**ISSUE:** Addition and alterations

**APPLICANT:** St. Paul's Episcopal Church

**LOCATION:** 228 S. Pitt Street

**BAR CASE #2006-0053**  
**May 17, 2006**

**Figure 1 South Pitt Street elevation**

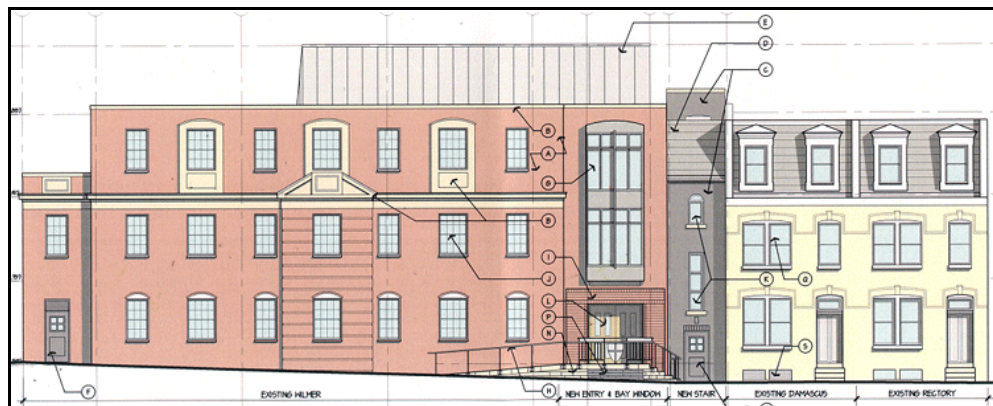
**Wilmer Hall front entrance** - Staff recommends that the existing double doors and diamond-pane transom which are original to the building and as designed by Smith, should be retained if at all possible. If not possible, the replacement elements should match the existing as closely as possible.
